**Meeting Notes
Wyckoff Eagle Harbor – OU1
October 27, 2015**

The participants met at EPA's office in Seattle to discuss three topics related to the offshore (OU-1) portion of the Wyckoff Eagle Harbor site. Key topics covered were:

Figure 4-2
Depth Intervals of TarGOST Detections
Wyckoff OU-1 Focused Feasibility Study

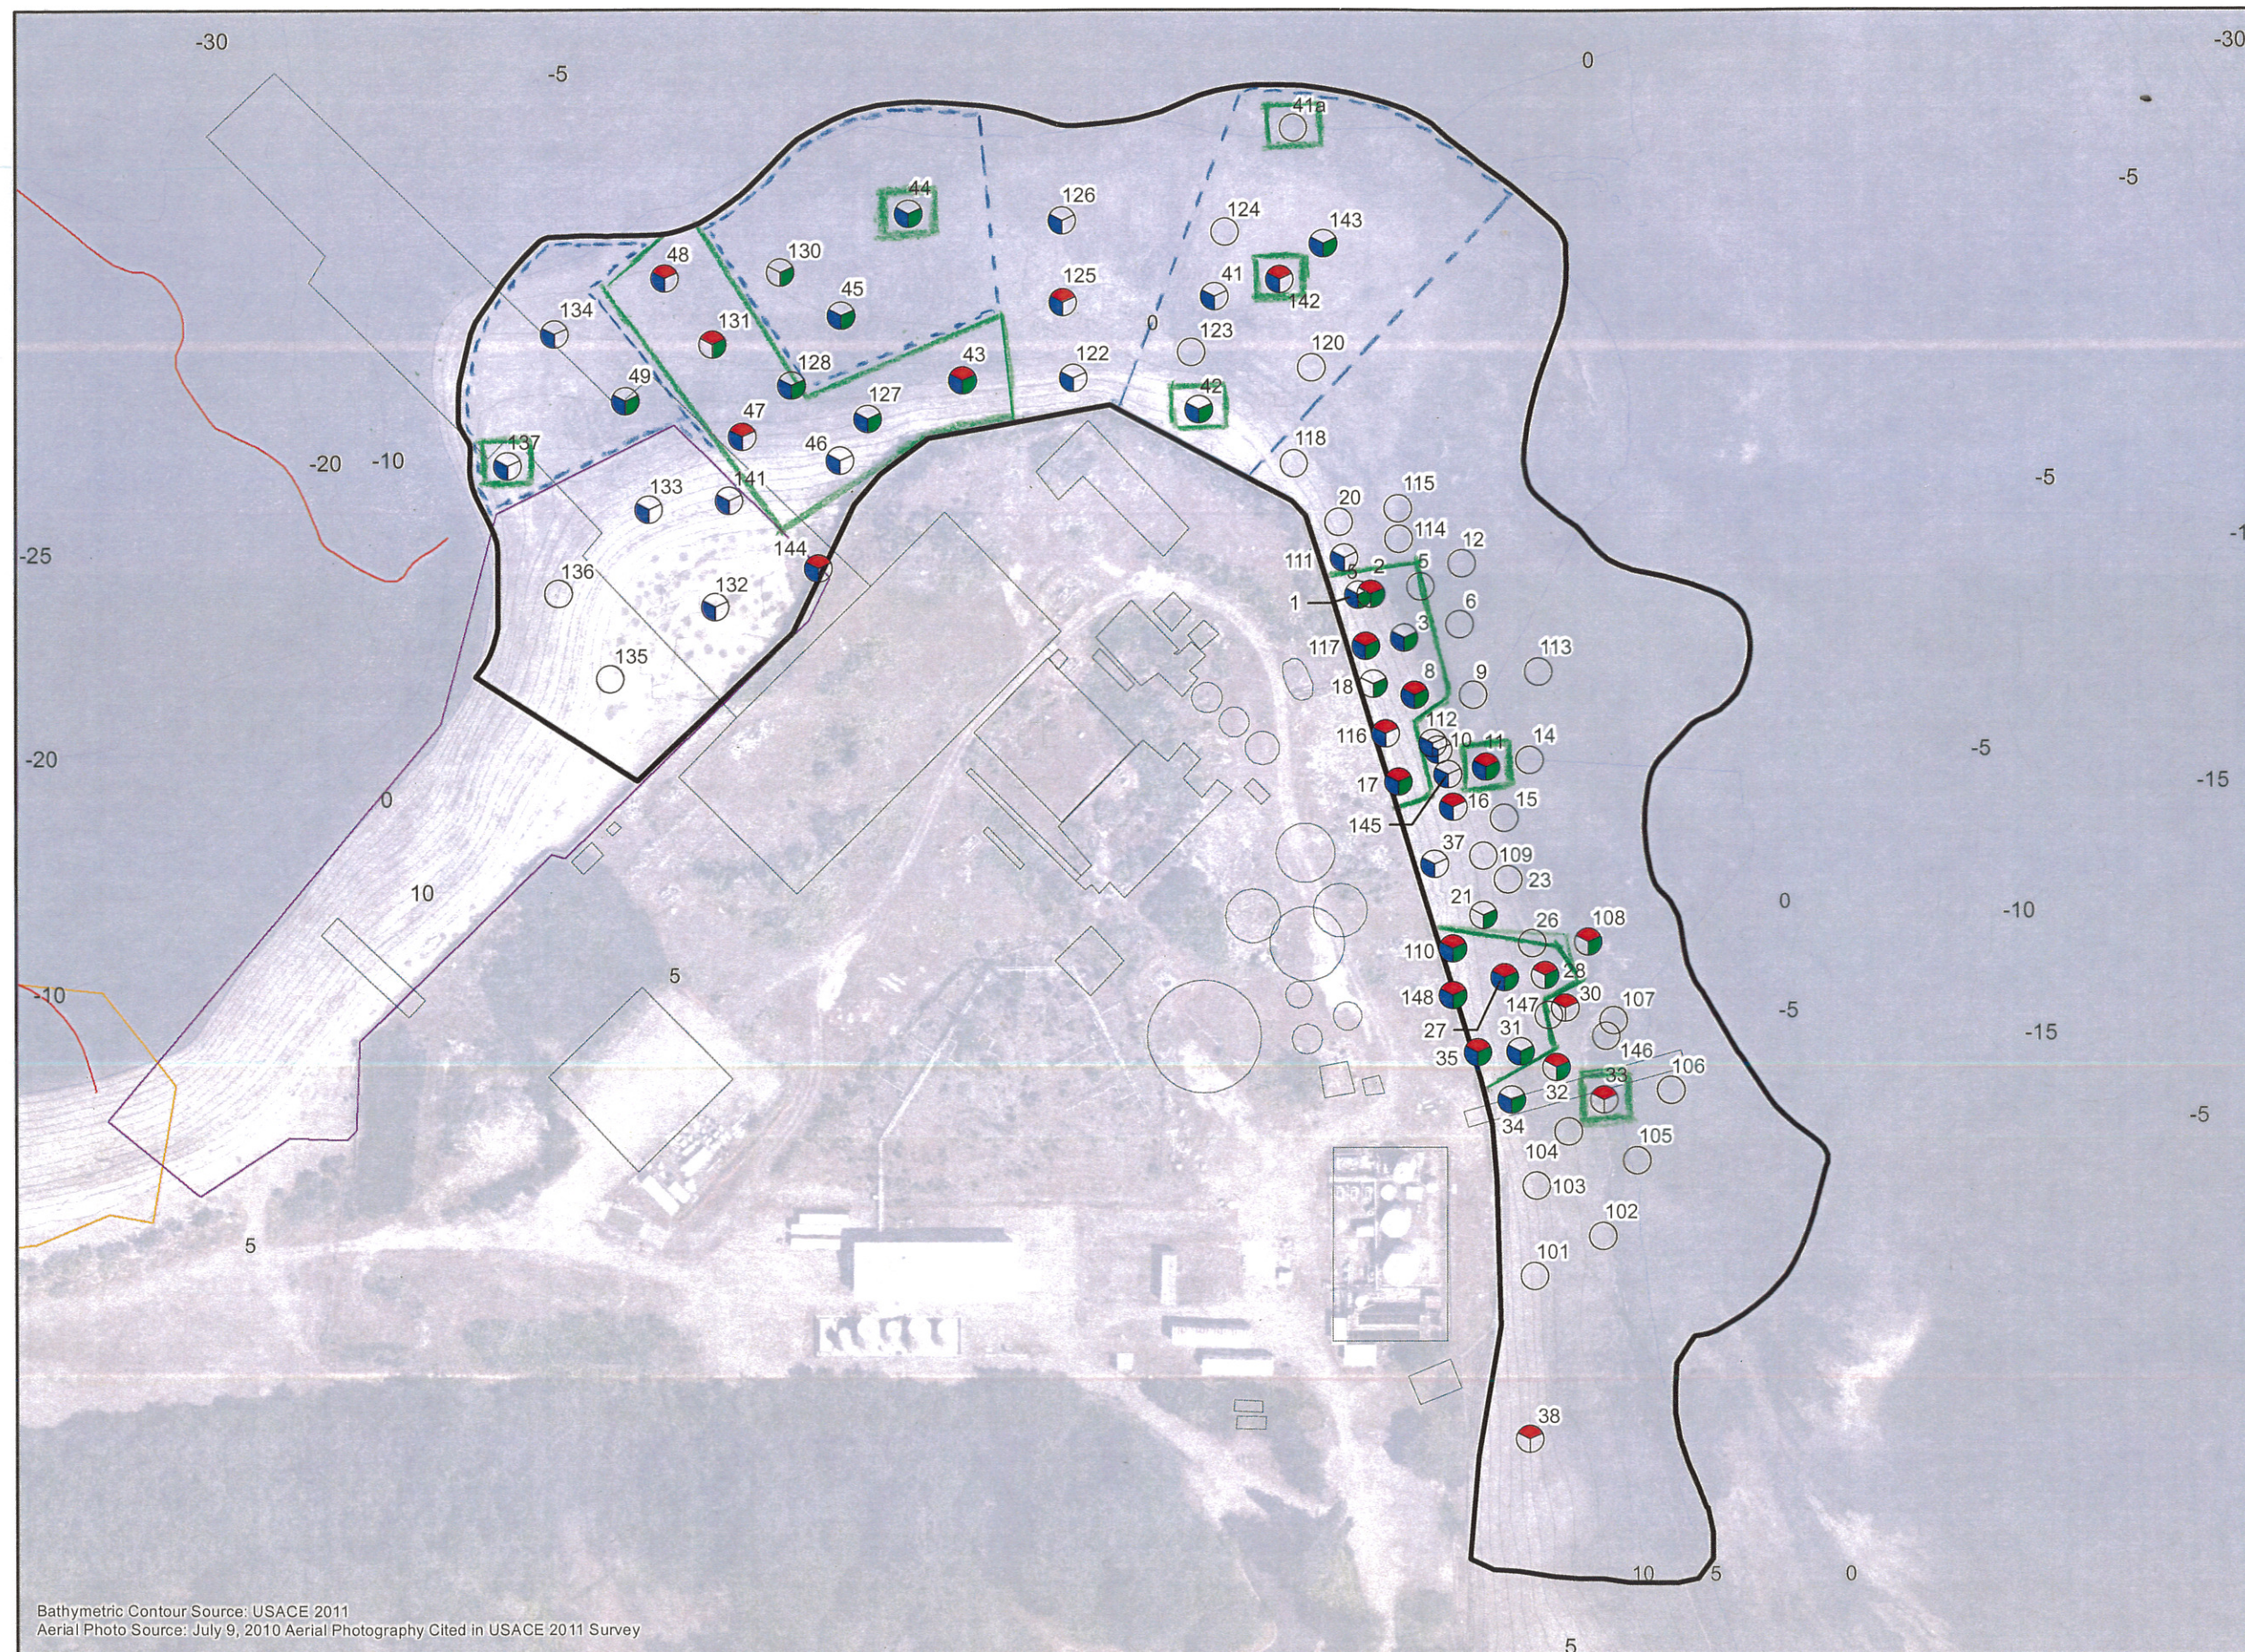
Participants discussed the cleanup area boundaries, using an Excel table summarizing the TarGOST log readings and a map, Figure 4-2 from the Field Investigation Report. These documents were shared with the group before the meeting. The team discussed each TarGOST log where there was some doubt as to whether the area should be treated with thin inset capping. The raw TarGOST log results, along with the duplicate log and confirmatory sediment core sample (where available) were considered. The team also reviewed the waveform data presented in Appendix B-2 of the OU-1 Field Investigation Report. Appendix B-2 was used to confirm that %RE readings at the sediment surface at several of the TarGOST locations were likely due to algae rather than PAH contamination. Team members also considered other lines of evidence, including persistent NAPL seeps locations and sediment samples from the 2011 sampling event.

The team agreed which TarGOST locations should be treated with thin layer capping. The attached spreadsheet summarizes the decisions reached for each TarGOST probe location. The resulting cleanup areas are shown on the attached map. The areas targeted for capping are smaller than presented in the draft FFS, which will reduce the cost of the remedy and minimize the impact to the existing beaches and eelgrass beds.

Participants agreed that further refinement is not needed on East Beach, where clean samples outside the proposed cleanup areas provide a clear and well justified boundary. The group identified three areas in North Shoal that would benefit from additional TarGOST borings to help define the areas to be capped. These areas are shown on the attached map.

Area	LOG #	Include in capping area?	Rationale, per Oct 27 Team Meeting
North Shoal	135	NO	Clean
North Shoal	136	NO	Clean
North Shoal	137	YES	Assume patch over this area for now. Use TarGOST during pre-design sampling to refine capping area around this location.
North Shoal	132	NO	Clean
North Shoal	133	NO	NAPL is very deep
North Shoal	144	NO	Clean
North Shoal	141	NO	NAPL is deep
North Shoal	49	NO	Do not include in cap footprint for now; contamination here is deep. Re-evaluate this station during pre-design
North Shoal	134	NO	NAPL is deep. Do include this area in pre-design sampling
North Shoal	46	YES	Thickness of NAPL and high %RE suggest subsurface NAPL could be source to surface sediments
North Shoal	47	YES	NAPL with %RE > 50 in top 3', also high %RE in deeper layers could act as source
North Shoal	128	NO	Clean - "hit" previously identified at surface is algae
North Shoal	131	YES	NAPL identified in top sections of core sample

□ = cleanup areas

□ = additional
TarGOST during
pre-design to refine
